Product Service Group CE Audio

Service Information

CORRECTION TO SERVICE MANUAL

CHANGES DURING PRODUCTION

AF9 BOARD - CIRCUIT DIAGRAM (PART 1)

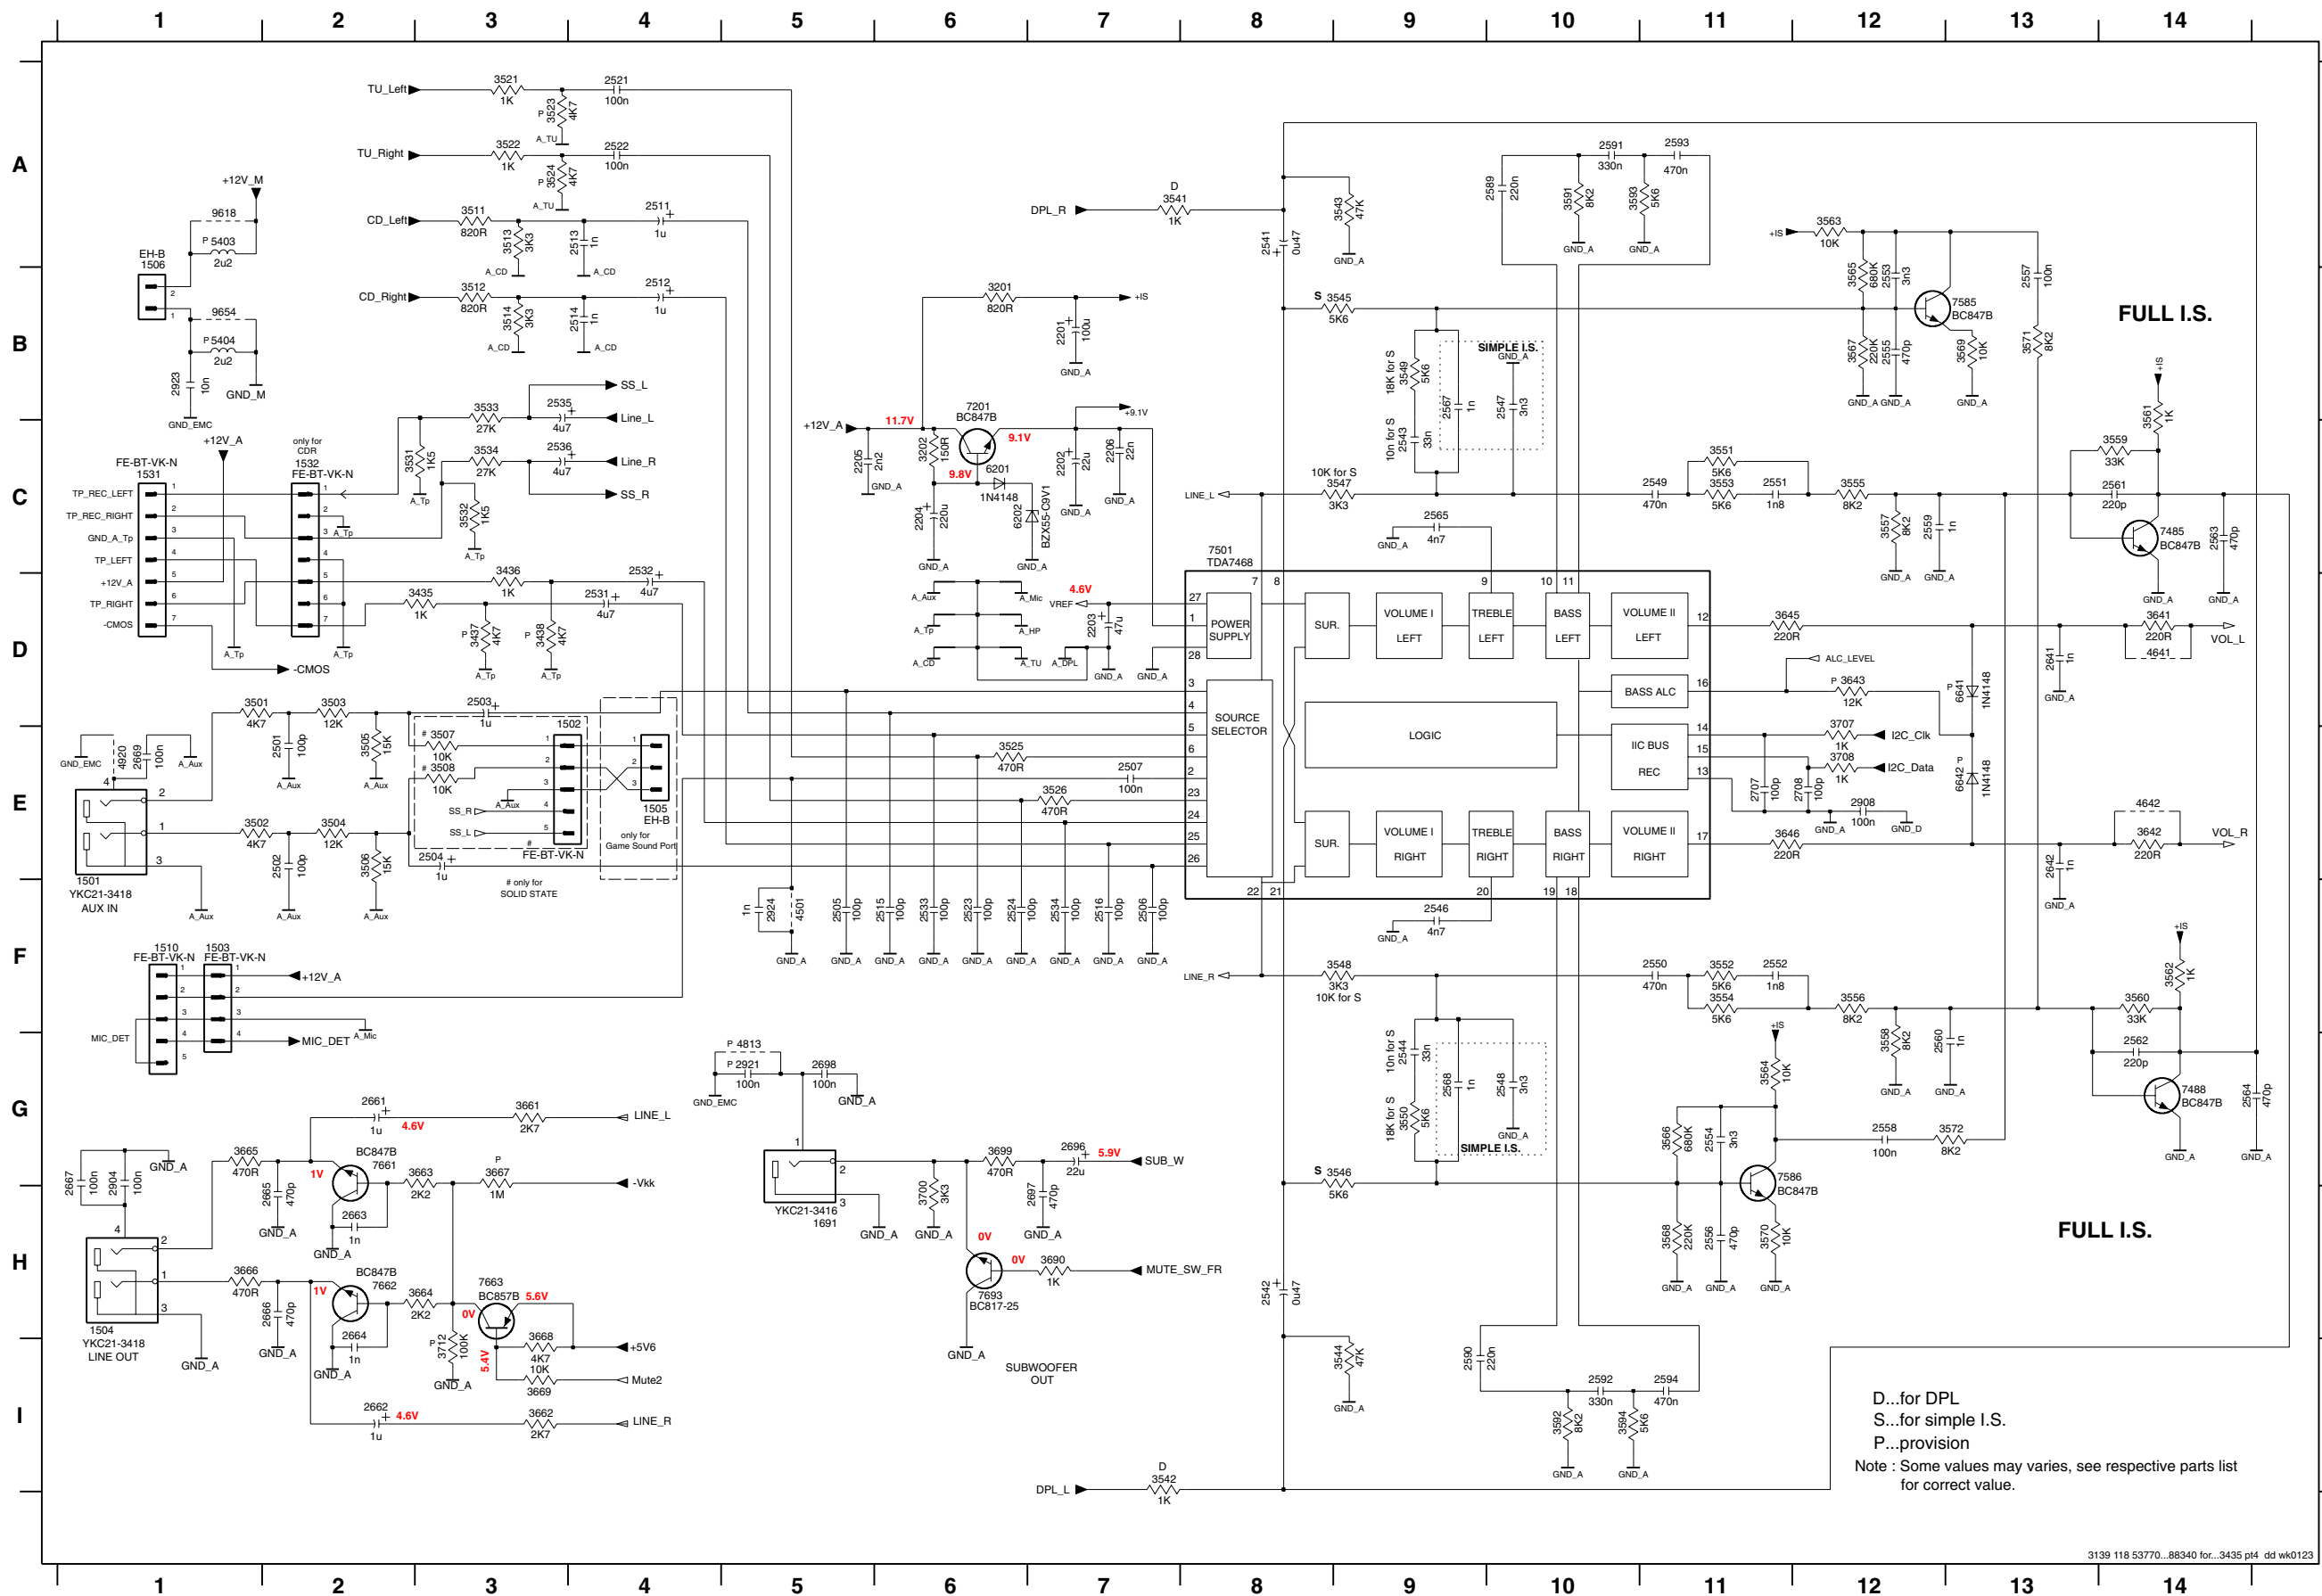
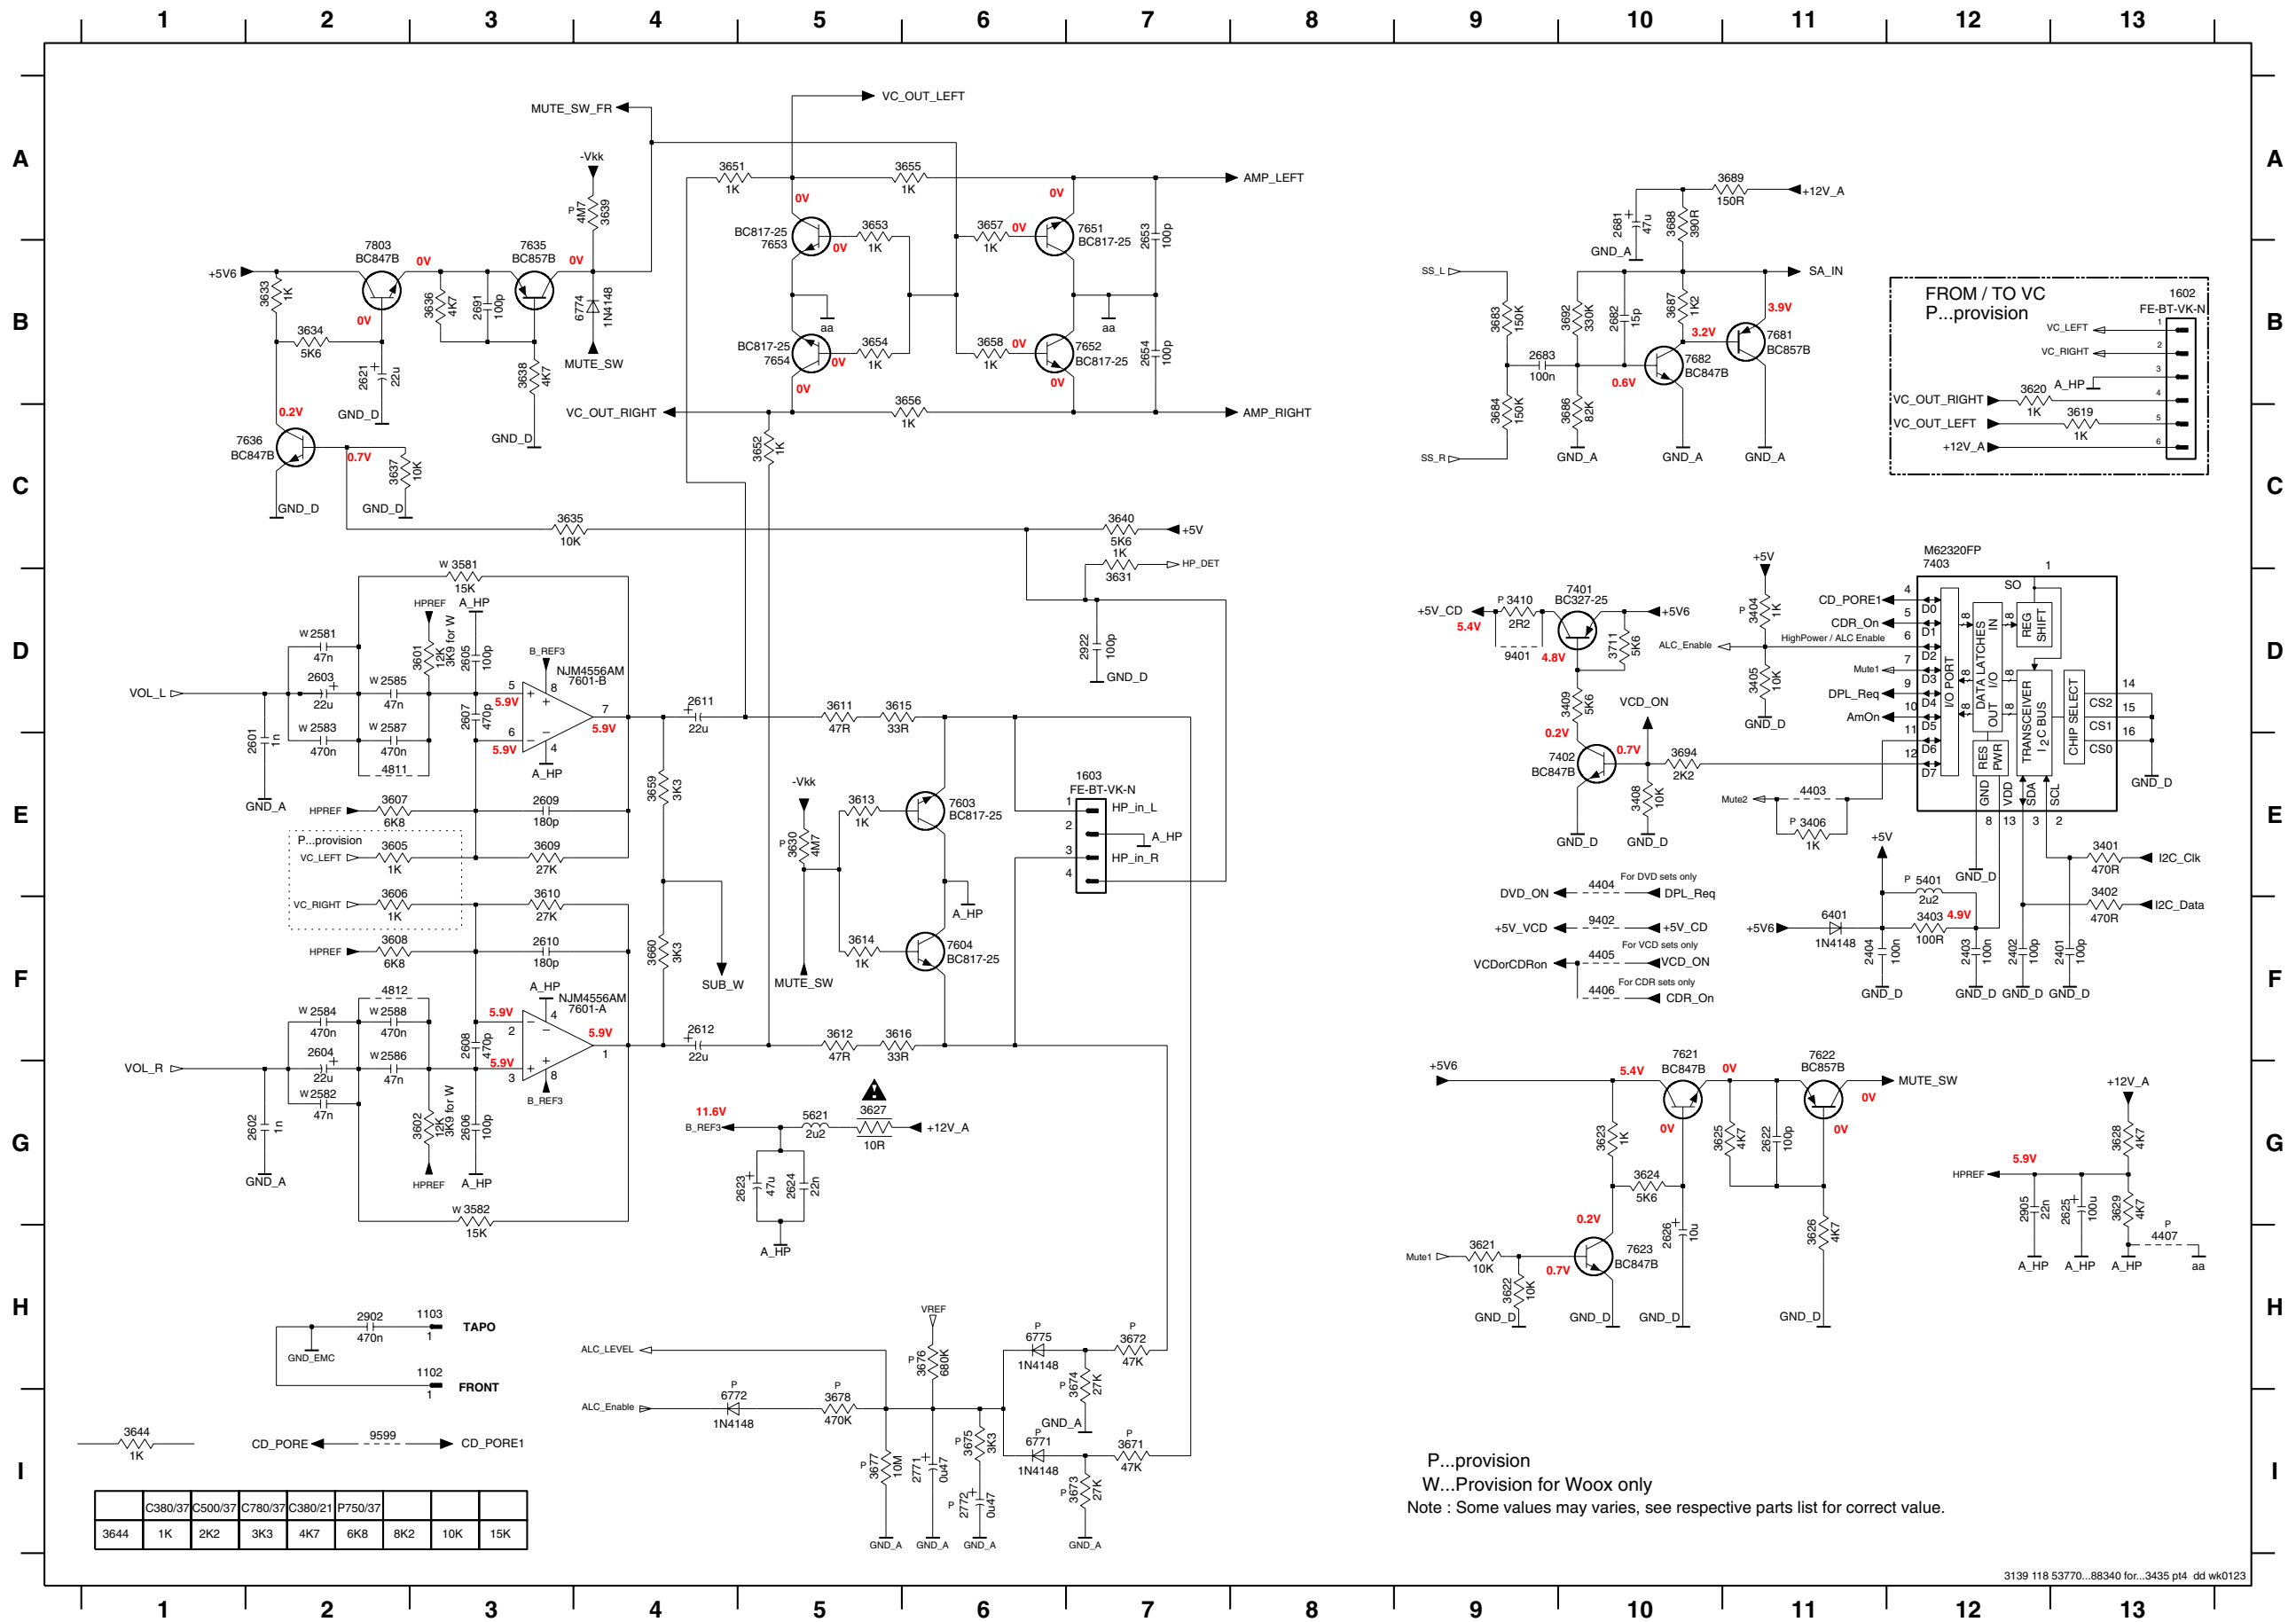
*From production week 0110 onwards pt.3 Board (identified by the last digit of the 12NC - 3139 113 34353) is introduced.

Reason : For process, EMC & ESD improvement.

Add 2950 4822 126 13881 470pF 5% 50V
2951 4822 126 13881 470pF 5% 50V
2952 4822 122 31765 100pF 2% 63V
2953 4822 126 13881 470pF 5% 50V
3820 4822 116 52176 10R 5% 0,5W
4921 4822 051 30008 0R Jumper 0603
Change 6206 4822 130 31878 1N4003G
Delete 9614 Bare wire

*From production week 0122 onwards the following has been changed for GSM solution.

Add 3525 4822 051 30471 470R 5% 0,062W
3526 4822 051 30471 470R 5% 0,062W
3645 4822 051 30221 220R 5% 0,062W
3646 4822 051 30221 220R 5% 0,062W
4153 4822 051 30008 0R Jumper 0603
4641 4822 051 30008 0R Jumper 0603
4642 4822 051 30008 0R Jumper 0603
Delete 3641, 3642

*From production week 0133 onwards the following has been changed to solve capacitor current leakage issue.

Change 2503 4822 124 22466 1uF 20% 50V
2504 4822 124 22466 1uF 20% 50V
2511 4822 124 22466 1uF 20% 50V
2512 4822 124 22466 1uF 20% 50V

*During production pt.4 Board (identified by the last digit of the 12NC - 3139 113 34354) is introduced. For this reason new layout and circuit drawing are enclosed.
